Rev.	Revision Description	Drawn by	Checked by	Approved by Designer	Approved by Contractor	Date
02	After FAT, for installation	Tamara Trogrlić	Antonio Aleksić	Grga Kolić		27.7.2026.
01	For manufacturing	Tamara Trogrlić	Antonio Aleksić	Grga Kolić		7.5.2026.
00	First issue	Tamara Trogrlić	Antonio Aleksić	Grga Kolić		27.2.2026.

Project: Reconstruction and Modernisation of HPP Perucica - Phase II

Title: Unit KA2 control cubicle circuit diagrams

Unit KA2 control cubicle circuit diagrams	DRAWING No.: PERU-01-19-170-31-002	REV No.: 02	= UBCJA10GH100
TITLE PAGE	Designer No.:	SALES No.:	PAGE
			PAGE
			1 / 158

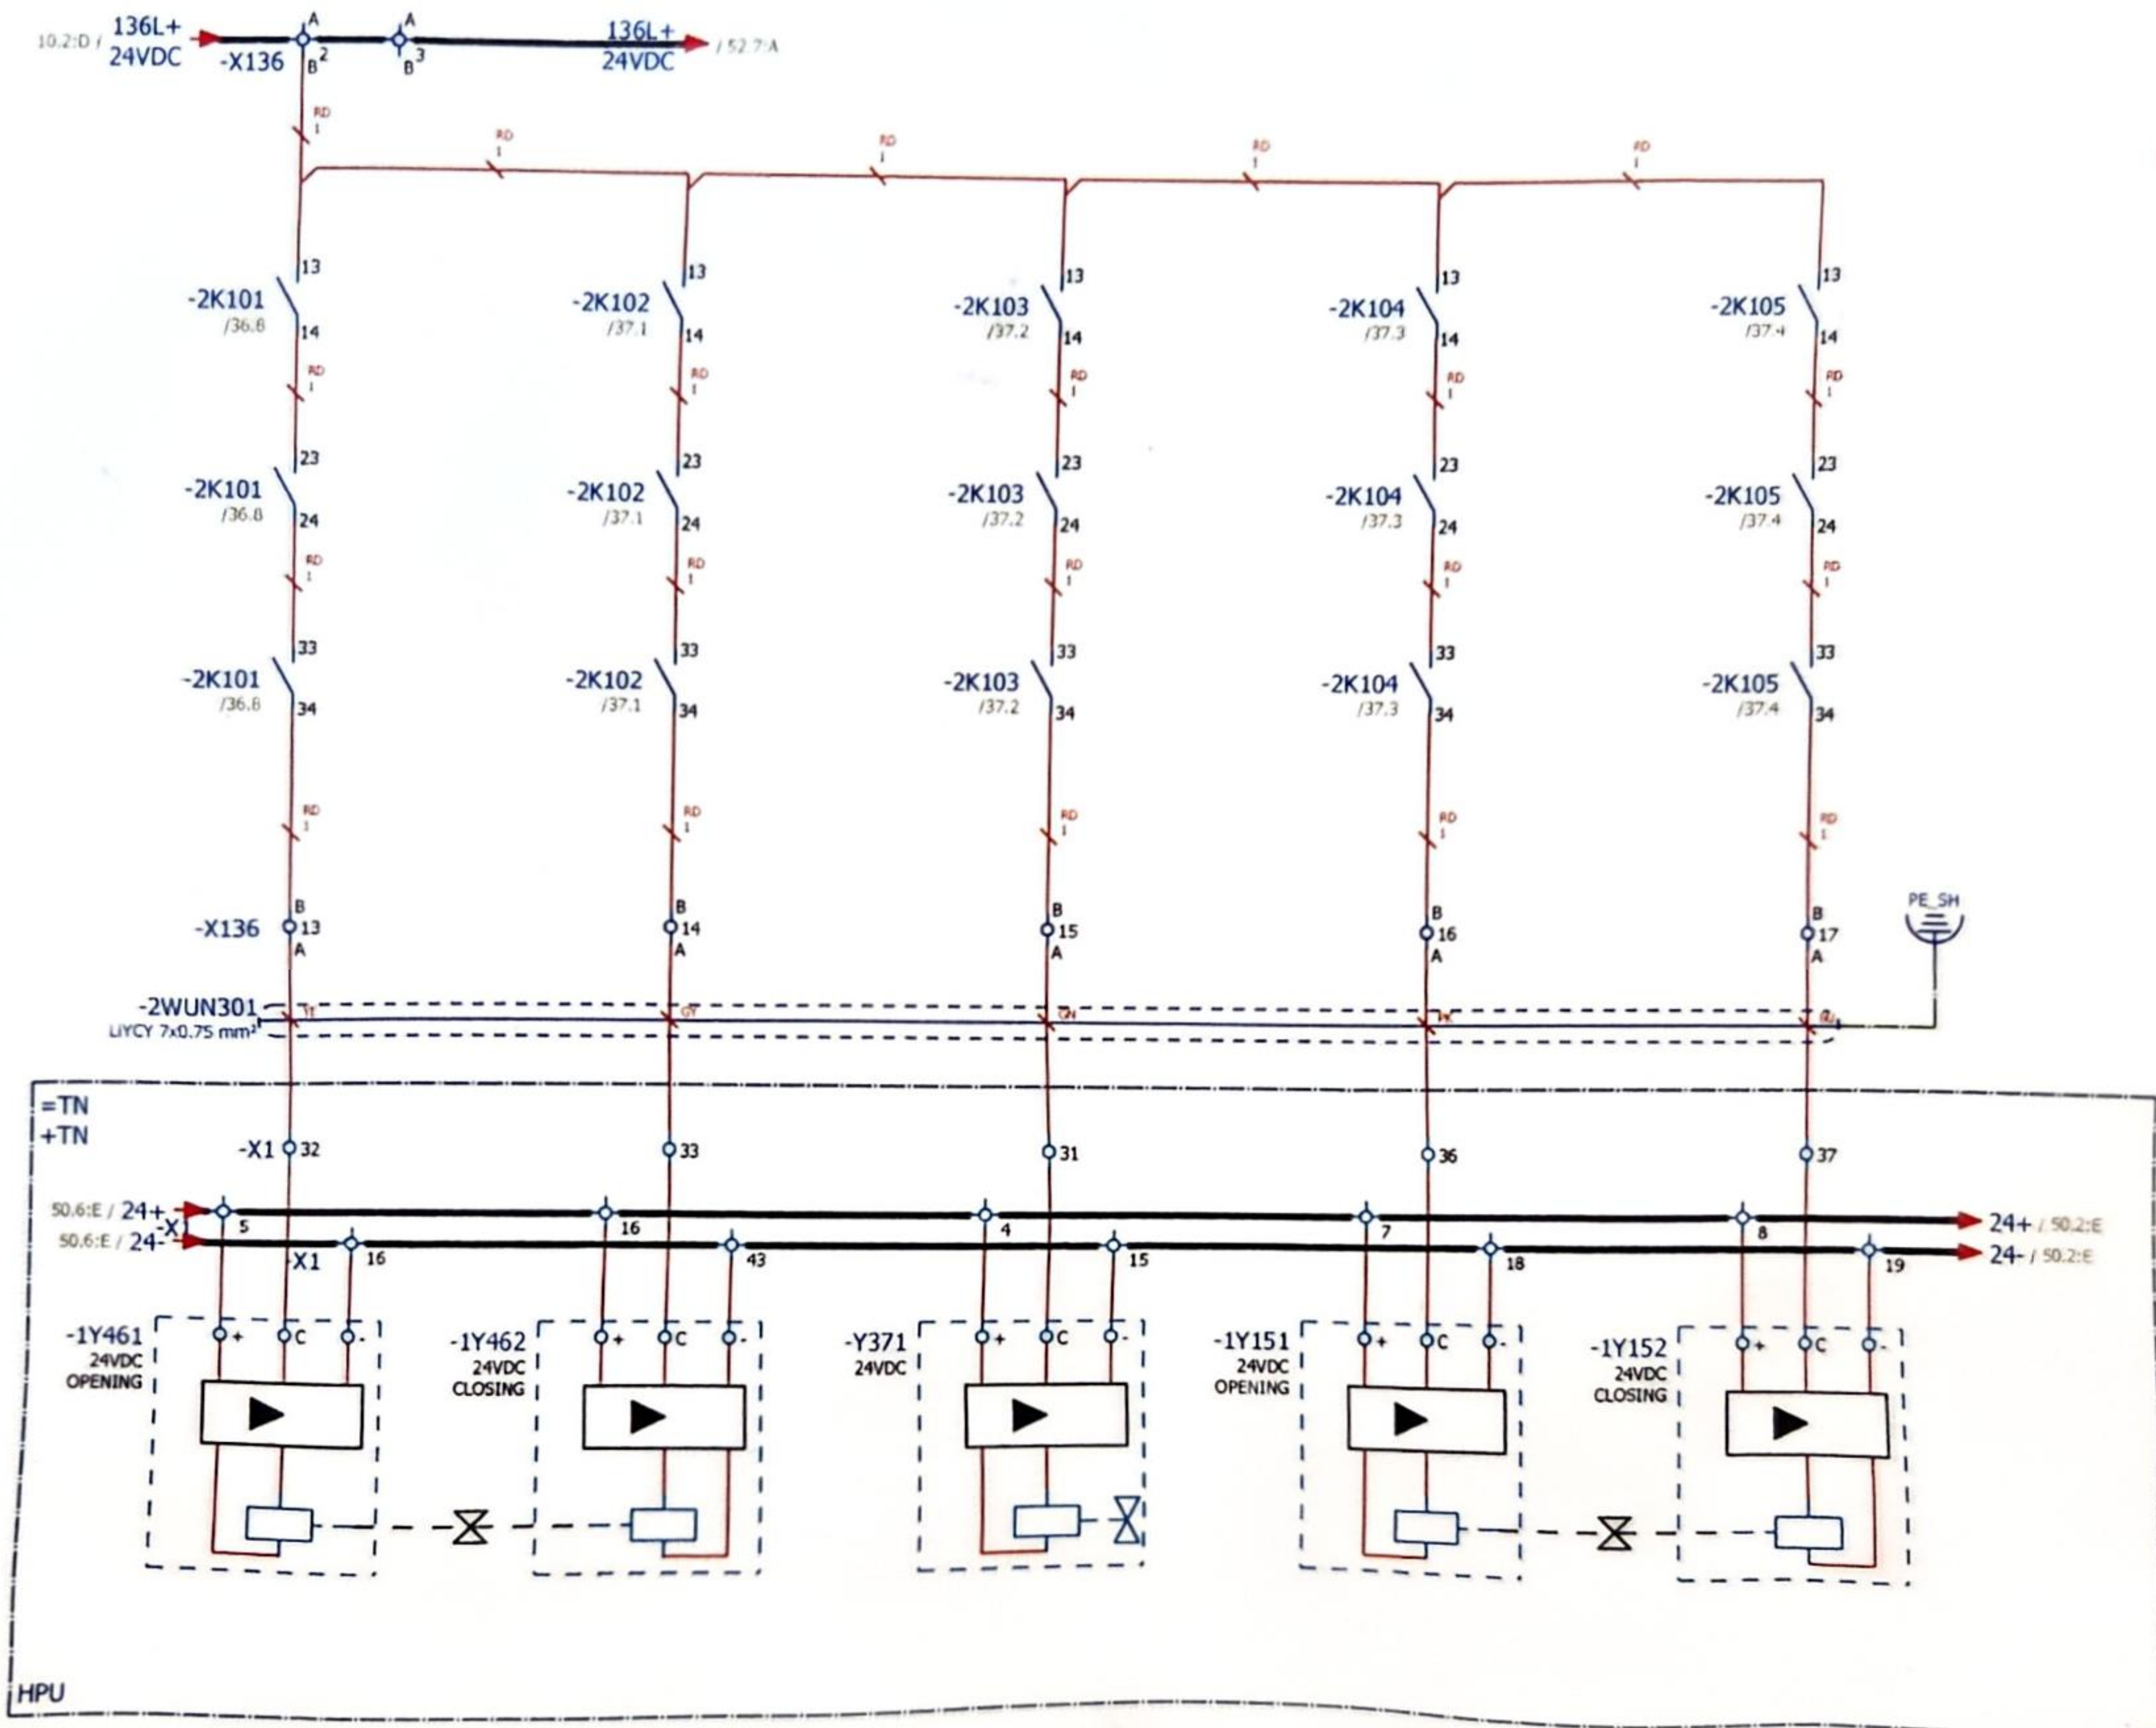
NOZZLE ~~OPEN~~
COMMAND

GENERATOR
PHASE 1 PHASE 2 PHASE 3
CURRENT

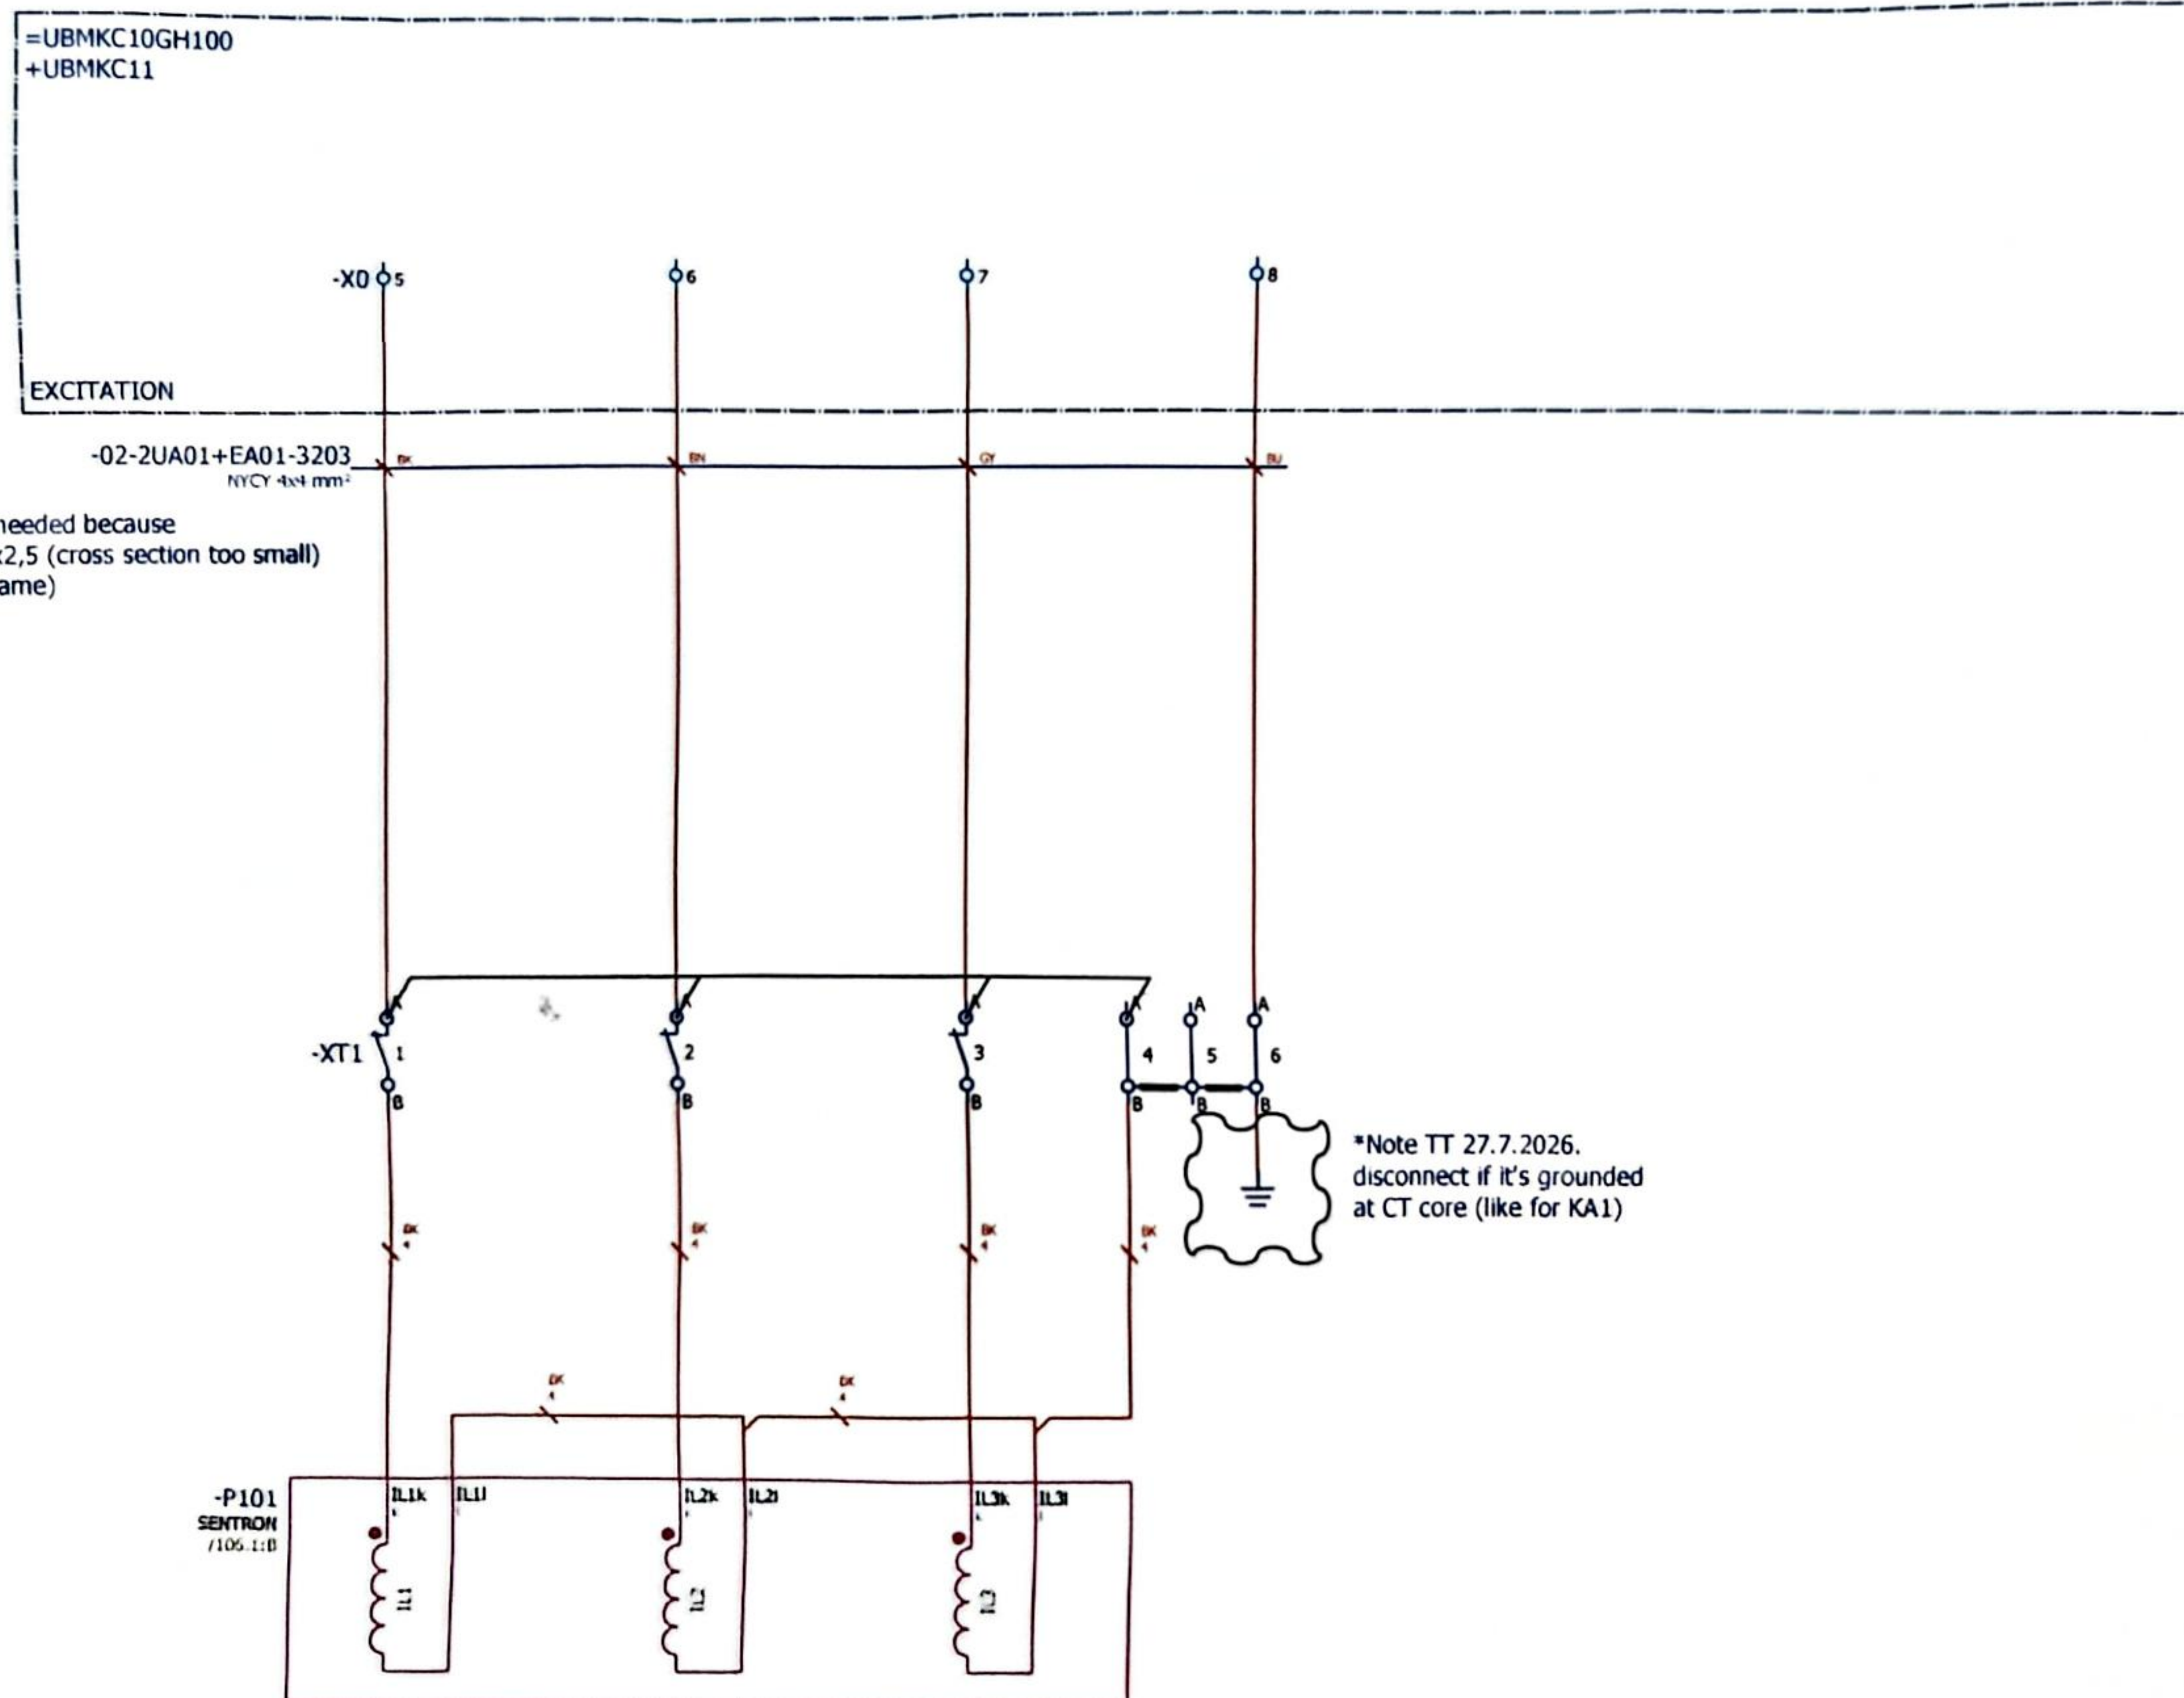
*Note TT 24.7.2026.
new cable NYCY 4x4 is needed because
the old cable is NYCY 7x2,5 (cross section too small)
(cable name stays the same)

AUXILIARY DISTRIBUTION - X2
COUPLER

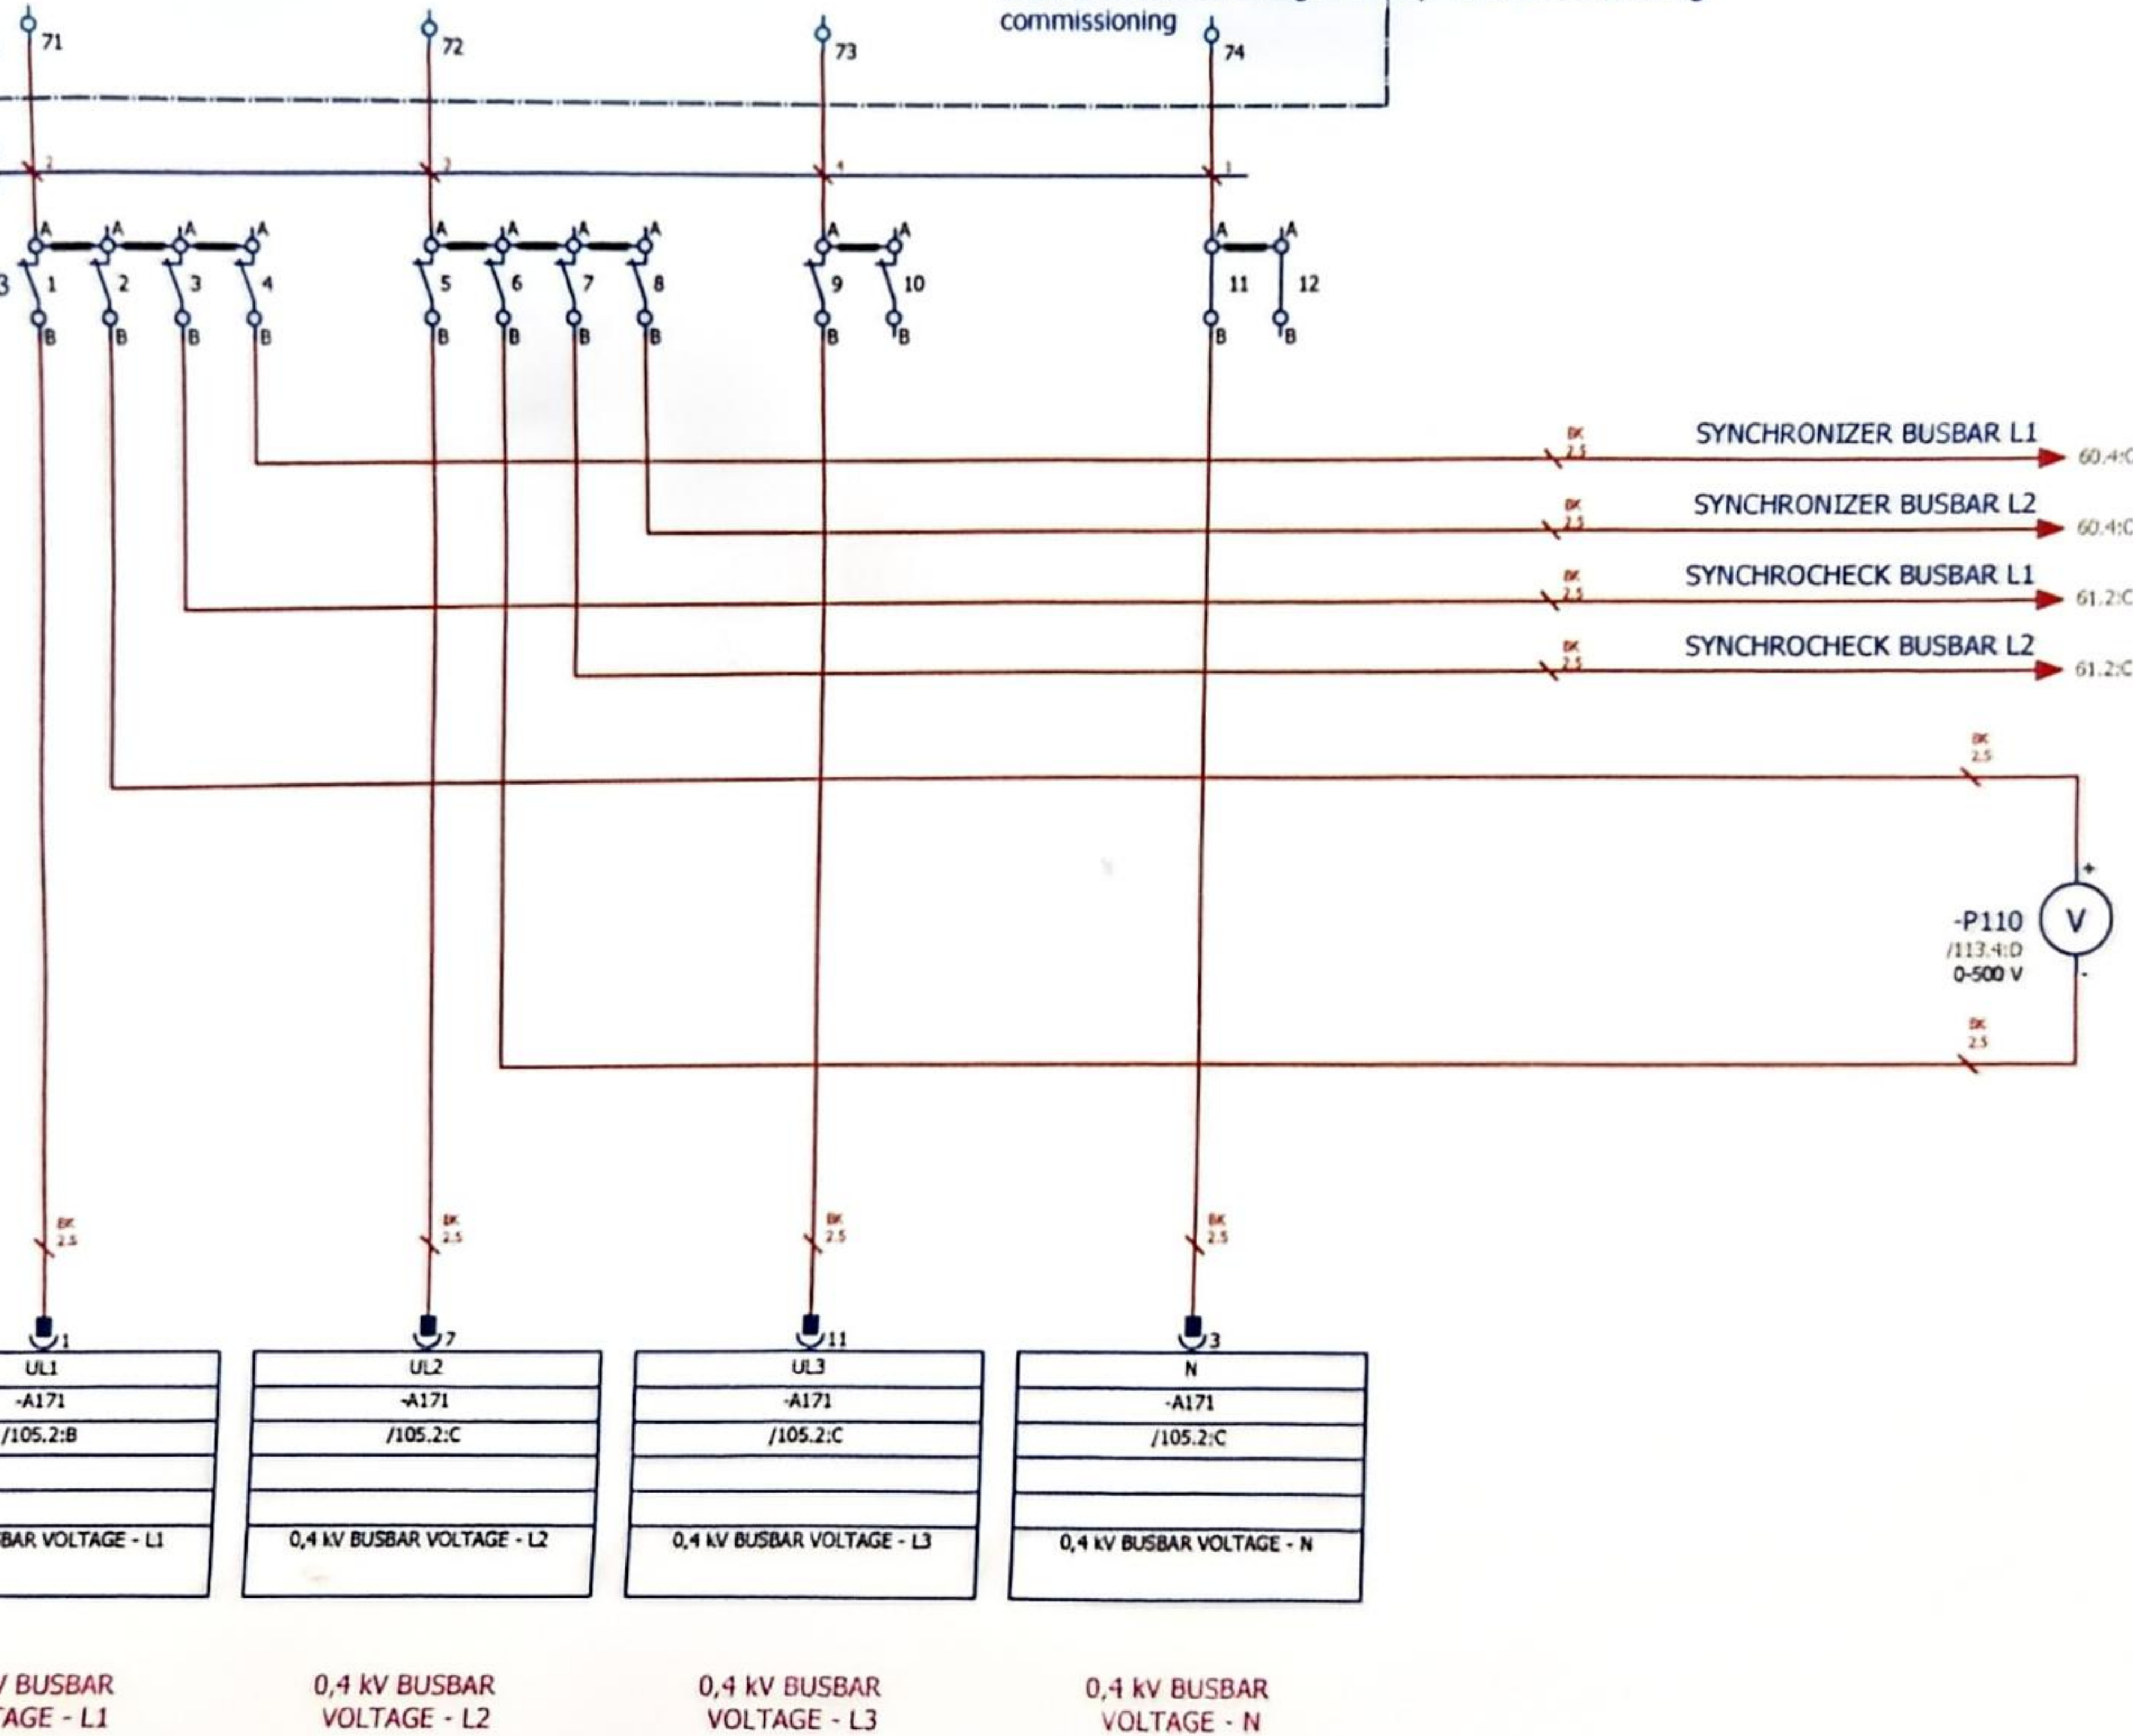
*Note TT 24.7.2026.
Cable core 1 is connected to X2:75, but should probably
be connected to X2:74 (according to documentation, plus
there is no internal wiring in X2:75). To be checked during
commissioning
